Access Compliance Report

Public Rights-of-Way

(Curb Ramps)

Intersection ID: 48474	Main Street: AUTUMN_OAK_DR	Cross Street: WONDERING_OAK_LN	Location: SE
ADA ID: 643BE5731385	Ramp Type: Perp	Initial Pass/Fail: Fail	Overall Compliance: No
			Severity Score: 33.75

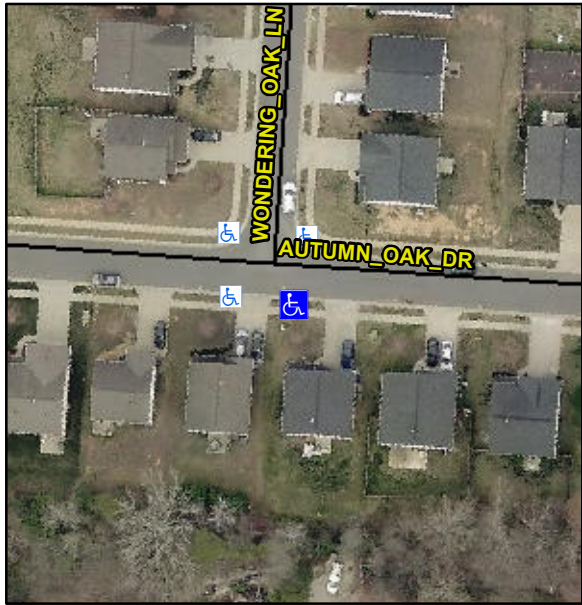
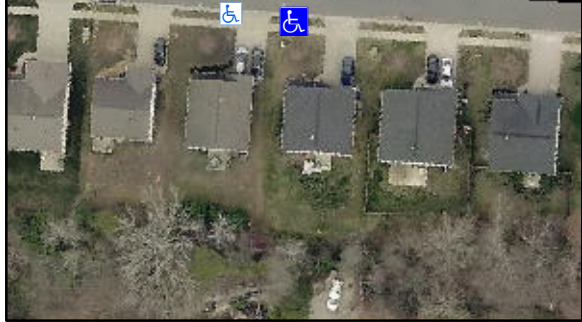
Codes/Mitigation Info/Possible Solution			Field Measurements/Component Compliance					
	Possible Solutions:		Compliance	Description	Data	Compliance	Description	Data
	Remove & Replace Entire Ramp.		N/A	Ramp Length (in)	48.0	No	Ramp Slope (%)	17.1
			No	Ramp Width (in)	47.0	Yes	Ramp XSlope (%)	1.5
			N/A	Flare Type LT	N/A	N/A	Flare Type RT	N/A
			N/A	Flare Slope LT (%)	N/A	N/A	Flare Slope RT (%)	N/A
			N/A	Flare Traversable LT?	N/A	N/A	Flare Traversable RT?	N/A
			N/A	Landing Length (in)	N/A	N/A	DWS Provided?	N/A
			N/A	Landing Width (in)	N/A	N/A	DWS Contrast?	N/A
			N/A	Landing Slope (%)	N/A	N/A	DWS Length (in)	N/A
			N/A	Landing X Slope (%)	N/A	N/A	DWS Full Width?	N/A
	Surveyor Notes:		N/A	Landing Curb? (Y/N)	N/A	N/A	DWS Offset (in)	N/A
	PROW/ADA:		N/A	Shared Landing?	N/A			
	Not Found, R304.5.1, R304.2.2		N/A	Gutter Ponding?	N/A	N/A	Gutter Slope (%)	N/A
			N/A	Gutter Lip Ht (in)	N/A	N/A	Gutter X Slope (%)	N/A
